No. 96-8

Belt Driven Seawater Pump (With Plastic Body) Changes.

All MCM, MIE models with Belt Driven Seawater Pump with plastic body.

2-Piece Body

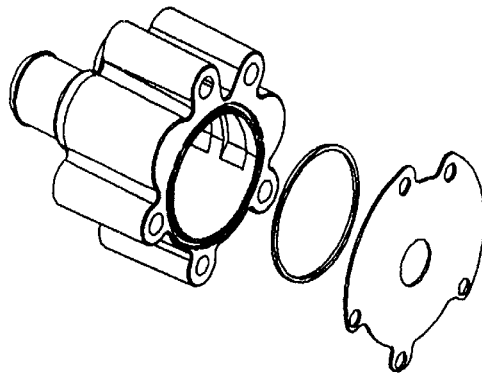
The original pump has been called the 2-piece body because it used a cover with gaskets and a wear plate.

A 1-piece body is now used in production and is available for servicing most of the older seawater pumps with the 2-piece body. This new 1-piece body gives 20% more water flow at higher engine RPM's than the older 2- piece pump and it eliminates 2 gaskets, 1 wear plate and the cover.

Replacement body, P/N 47-72774A40, for the 2-piece body pump has been made No Longer Available. To help you service both body types of seawater pumps, several kits have been made available. These kits and their use are listed on the reverse side.

46-72744A40 Body: No Longer Available. Order the required replacement parts from the correct list below.

Part Number	Description	Content
46-807151A14	Body/Impeller Kit	The 1-piece body comes with all fasteners, quad rings and an impeller.

Part Number	Description	Content
46-72774A89	Body/Impeller Kit	The 2-piece body comes with a quad ring, all gaskets and an impeller.
47-59362A 4	Impeller/Gasket Kit	The impeller comes with a quad ring and all gaskets.
